## V2500-A1/A5/D5 SERIES PROPULSION SYSTEMS SERVICE BULLETIN

This document transmits the Revision 1 to Service Bulletin V2500-ENG-75-0103 and the Revision 1 to the Supplement

# V2500-ENG-75-0103

ENGINE – LP TURBINE – ACTIVE CLEARANCE CONTROL C-TUBE WITH CHANGED MATERIAL FOR END  
FERRULES

Connector tube assembly - Replacement of sealing tubes  
Figure 1 (Sheet 1 of 5)

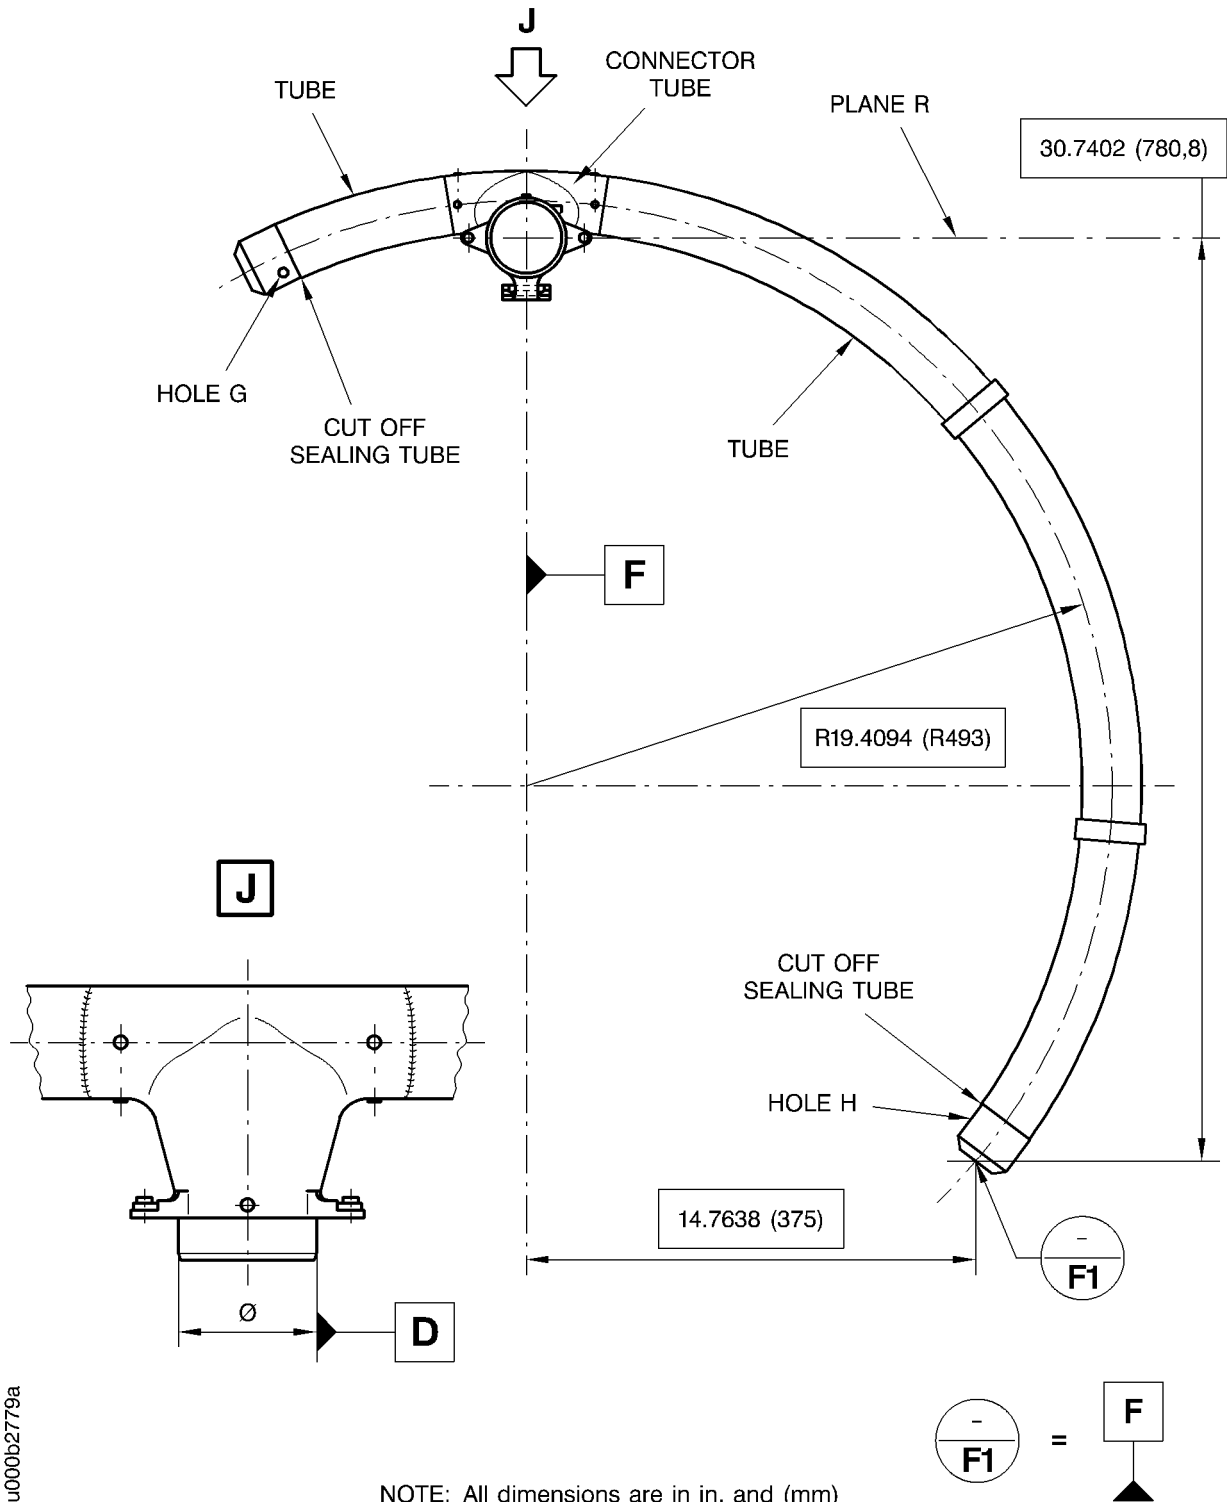
| (3) Remove the Sealing<br>Tube  | Refer to Figure 1 (sheet 1 or 2 of 5).<br>Use applicable machining equipment and IAE 3M14523<br>cut off and welding fixture 1 off. |

Connector tube assembly – Replacement of sealing tubes  
Figure 1 (Sheet 2 of 5)

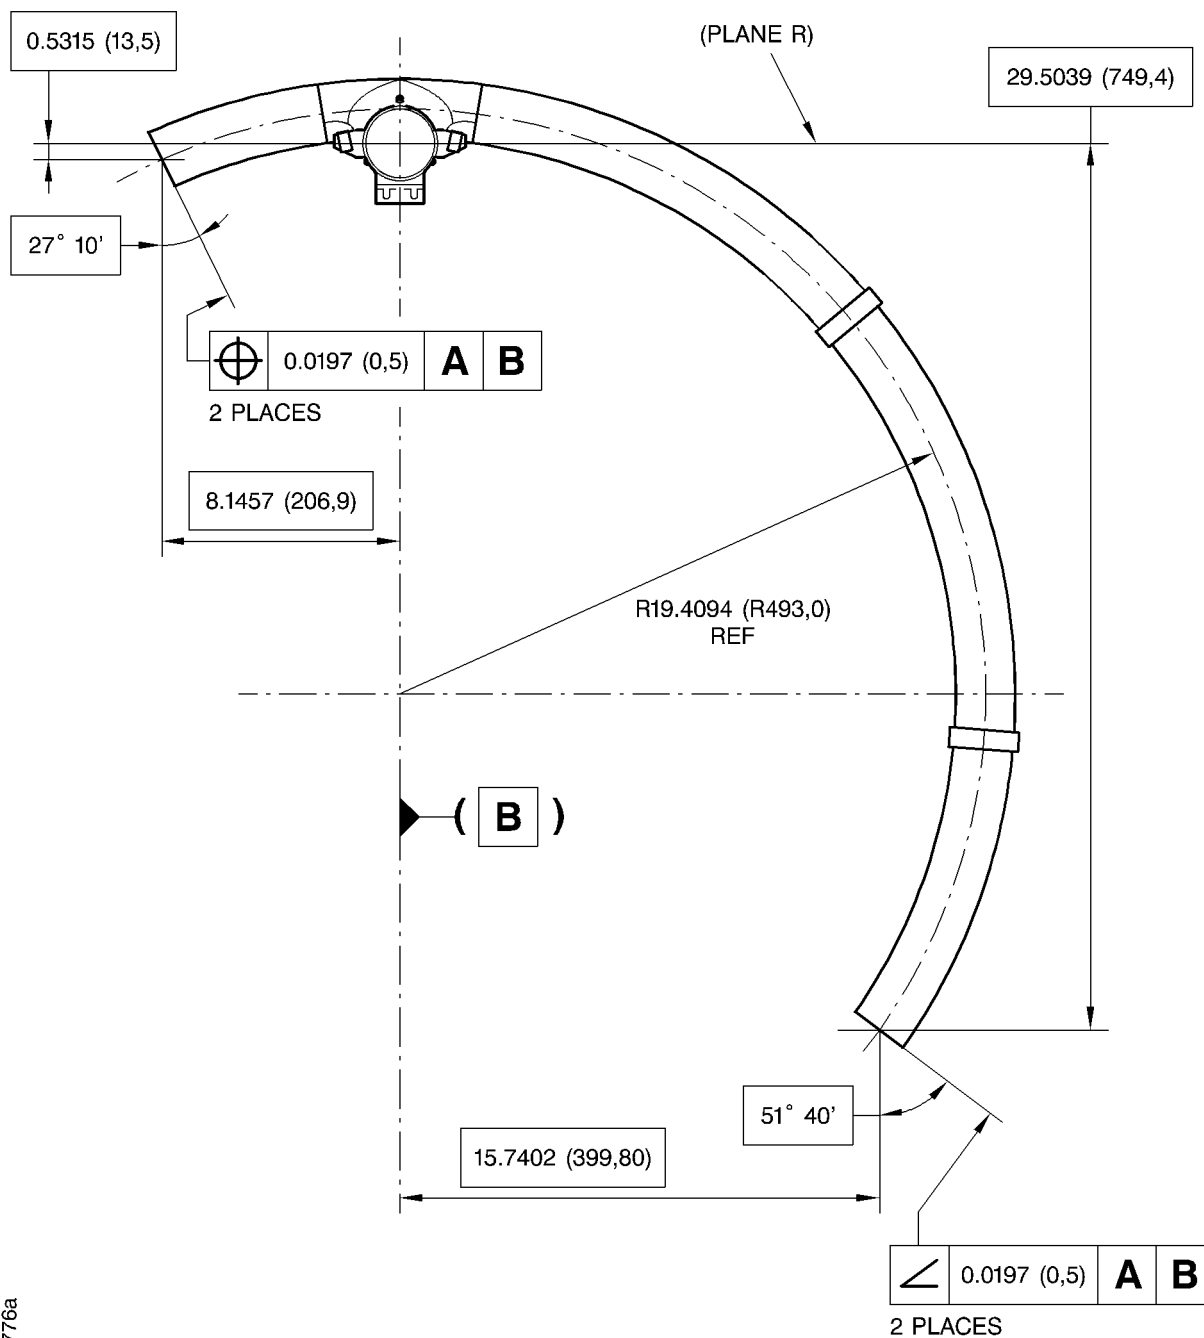
NOTE: Figure 1, sheet 1 of 5 and 2 of 5  
 Reflect different configurations of the  
 T-connector.

Connector tube assembly – Replacement of sealing tubes  
Figure 1 (Sheet 3 of 5)

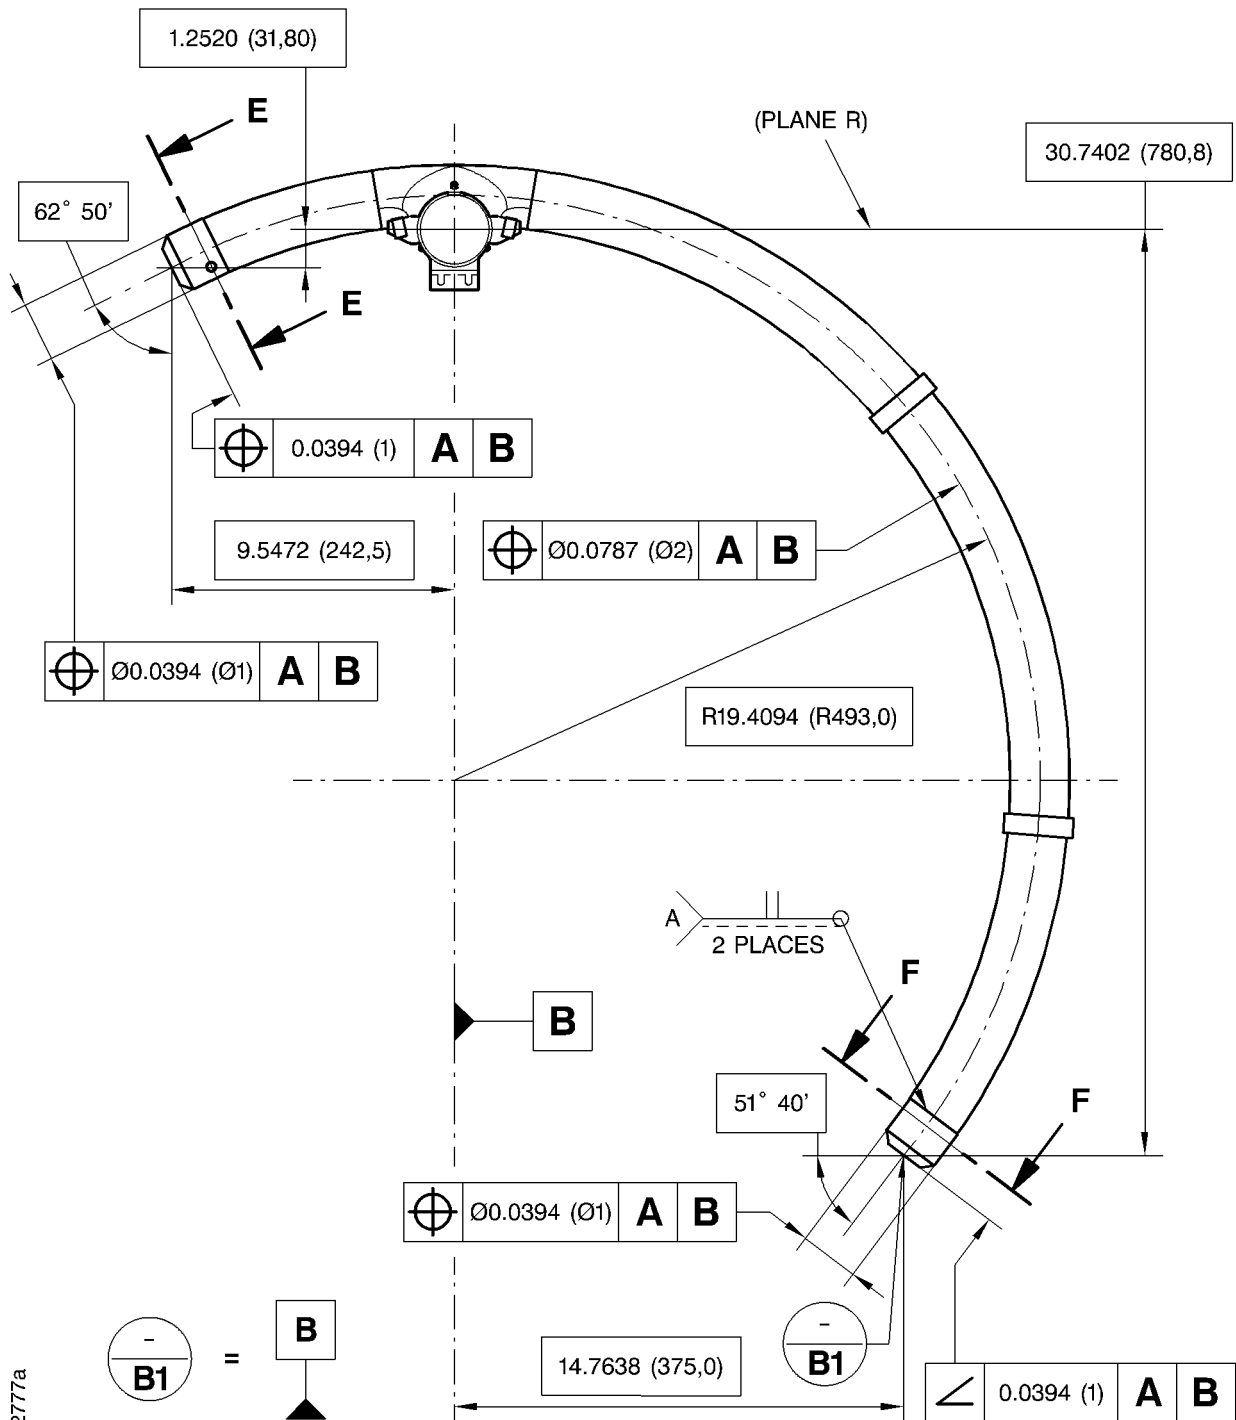
| (4) Examine the machined<br>area  | Refer to Figure 1 (sheet 3 of 5). Use applicable<br>inspection equipment.  |

Connector tube assembly – Replacement of sealing tubes  
Figure 1 (Sheet 4 of 5)

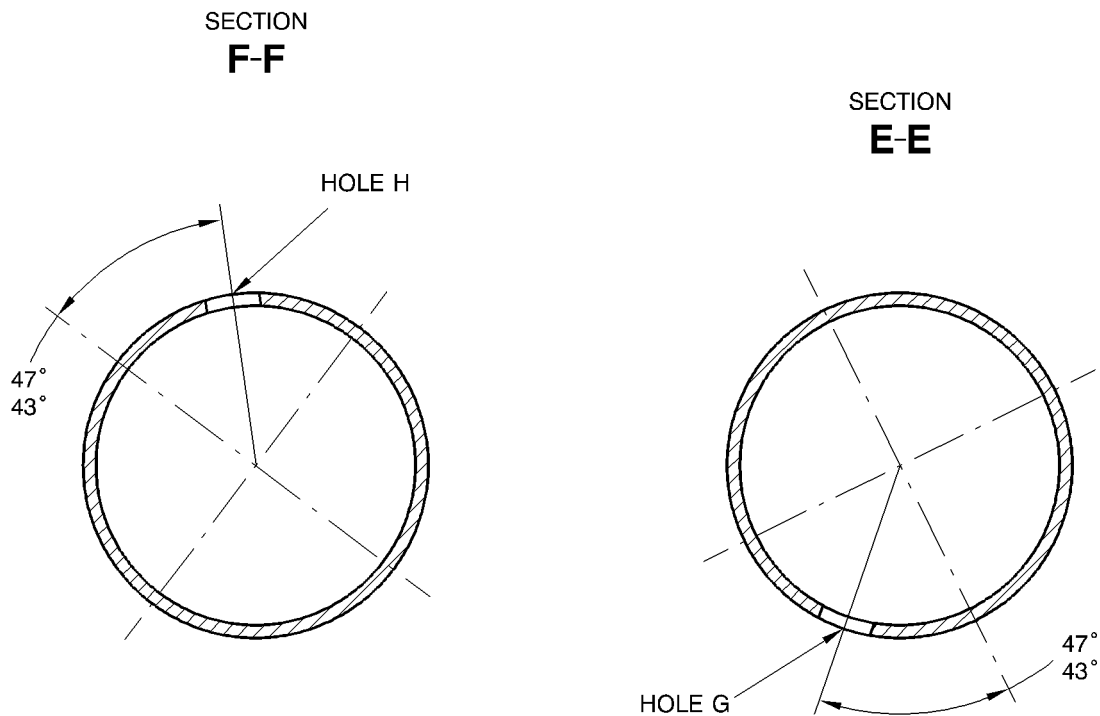
| (6) Weld in the<br>replacement Sealing<br>Tube (01-341) to the<br>Connector Tube<br>Assembly 01-010 | Refer to SPP TASK 70-31-13-310-501 and Figure 1<br>(sheet 4 of 5 and 5 of 5).  |

Provide an argon gas backup. Flow argon gas into  
 the tube during the weld repair. Weld in a  
 protective atmosphere. Use CoMat 03-288 or 03-195  
 welding material and IAE 3M14523 cut off and  
 welding fixture 1 off.

| (8)  | Examine the welded areas dimensionally                          | Refer to Figure 1 (sheet 4 of 5). Use applicable inspection equipment.  |

Connector tube assembly – Replacement of sealing tubes  
Figure 2 (Sheet 1 of 5)

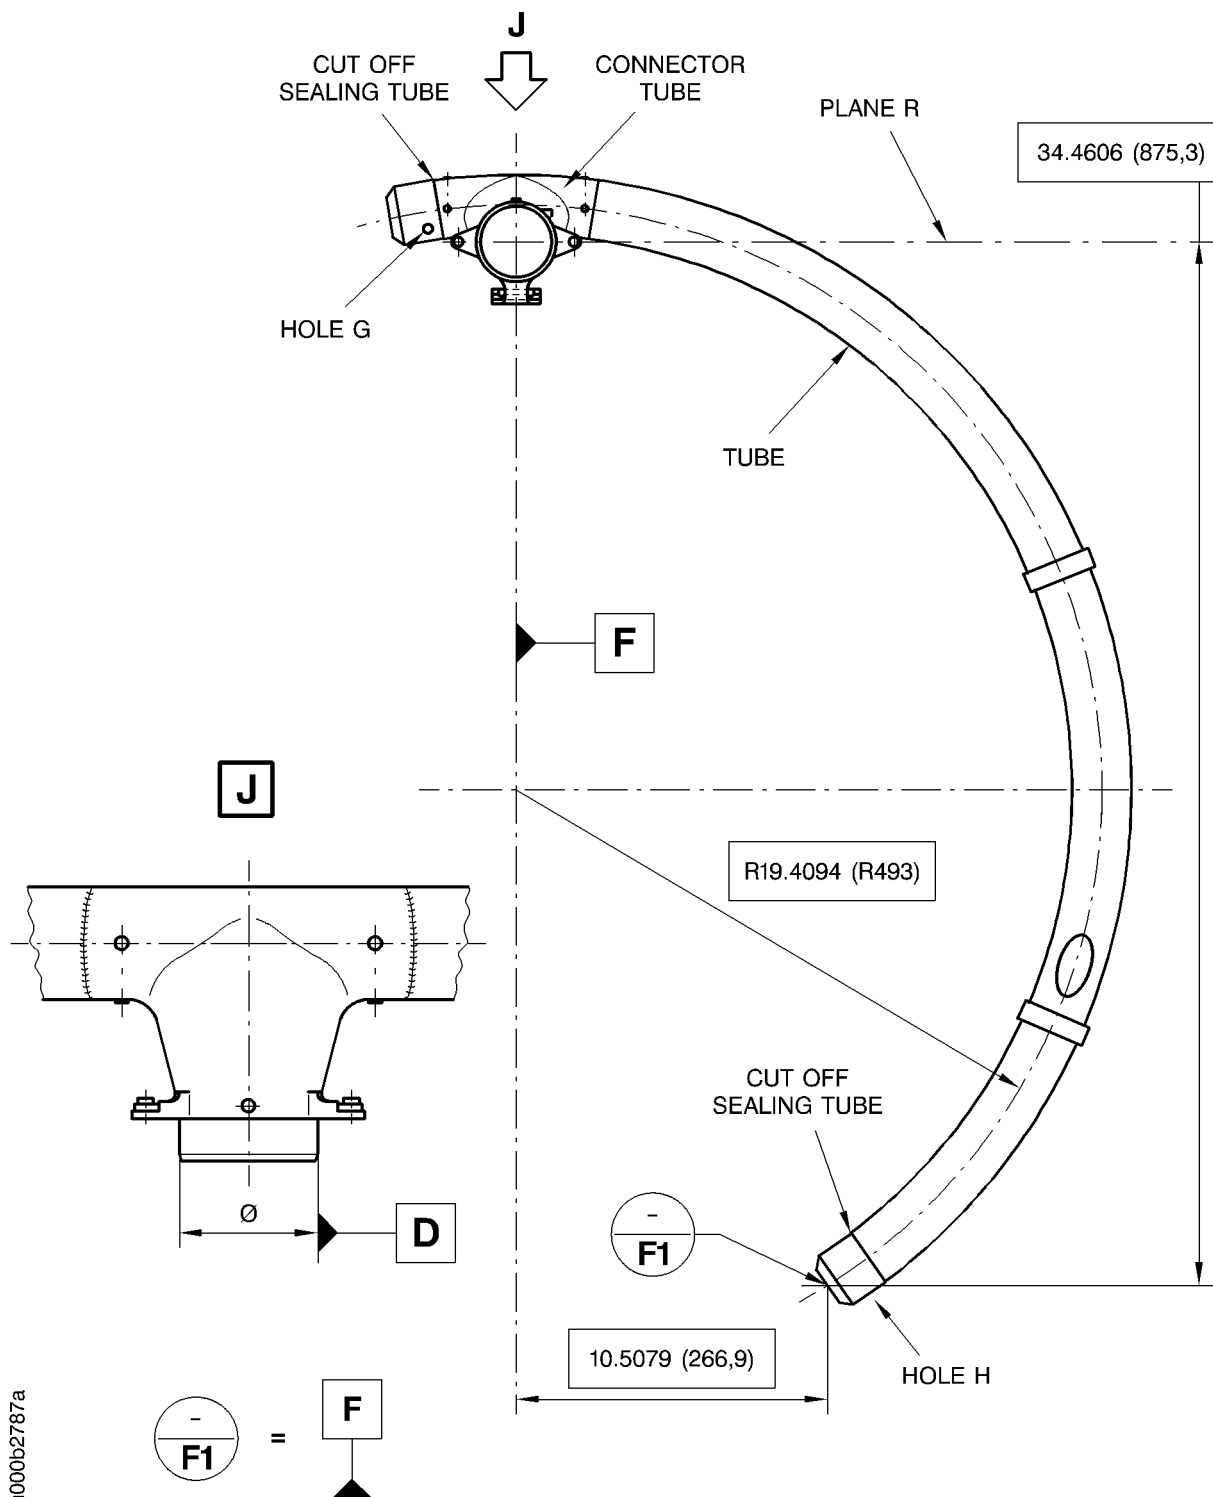
| (3) | Remove the Sealing Tube | Refer to Figure 2 (sheet 1 or 2 of 5).<br>Use applicable machining equipment and IAE 3M14523 cut off and welding fixture 1 off. |

Connector tube assembly – Replacement of sealing tubes  
Figure 2 (Sheet 2 of 5)

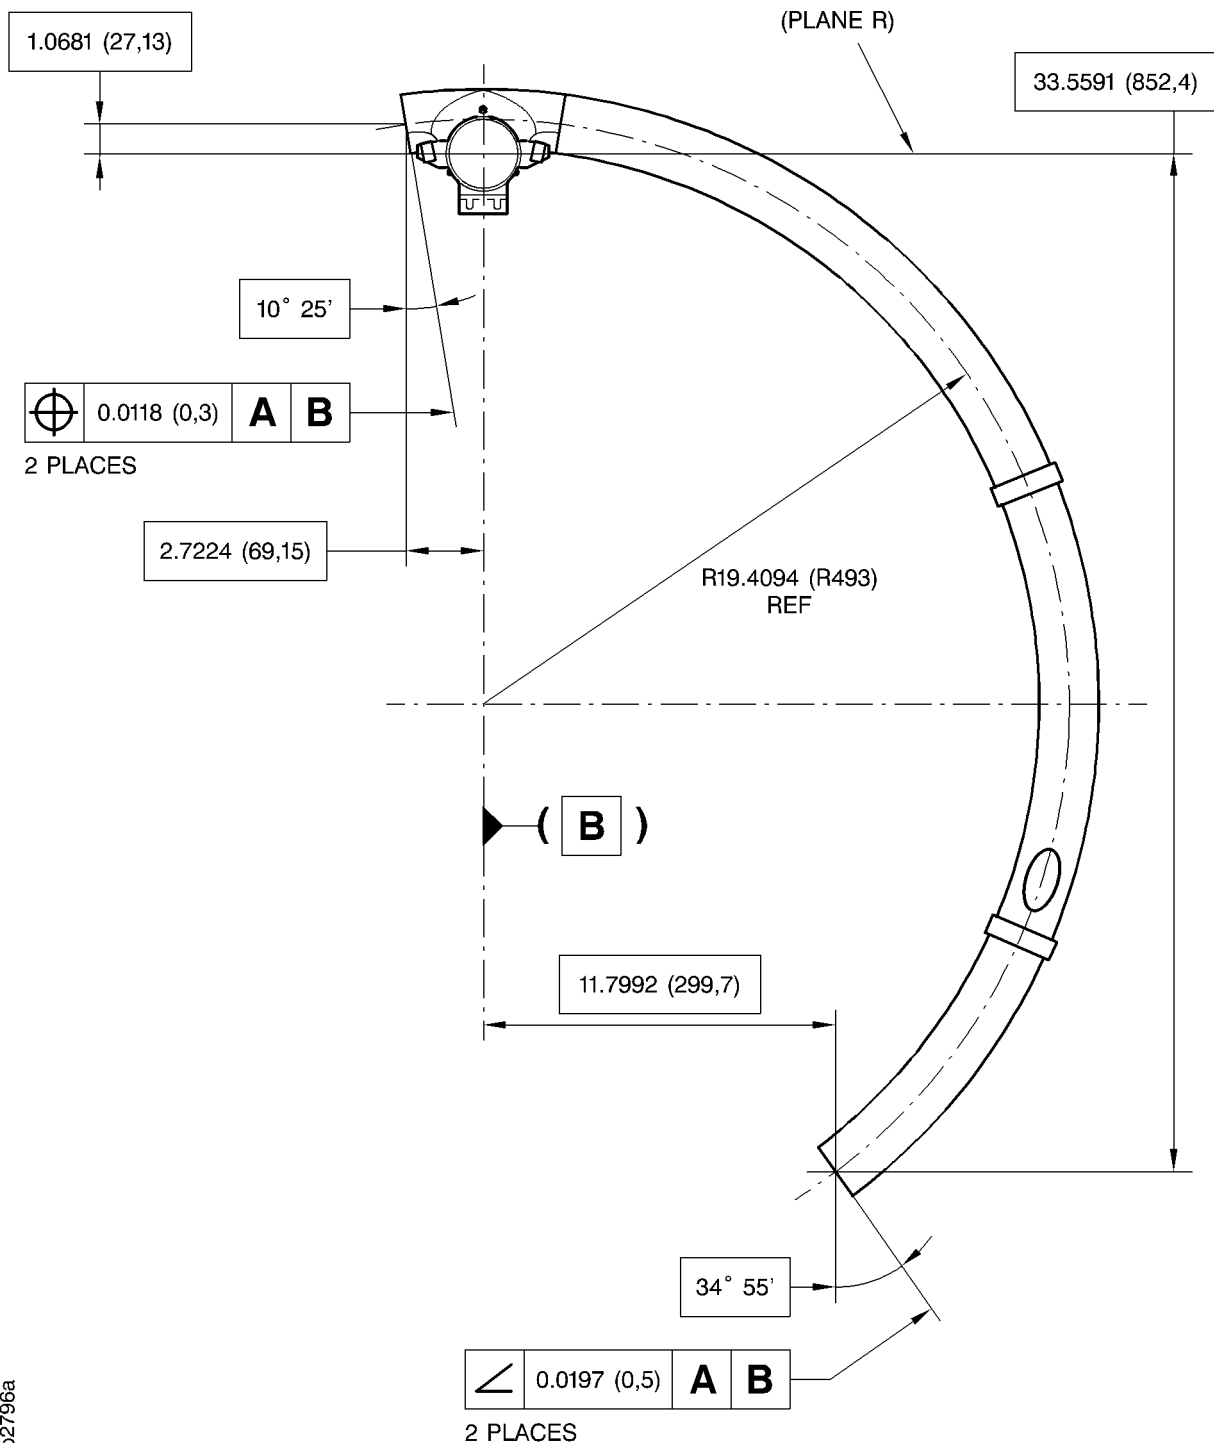
NOTE: Figure 2, sheet 1 of 5 and 2 of 5.  
Reflect different configurations of the T-connector.
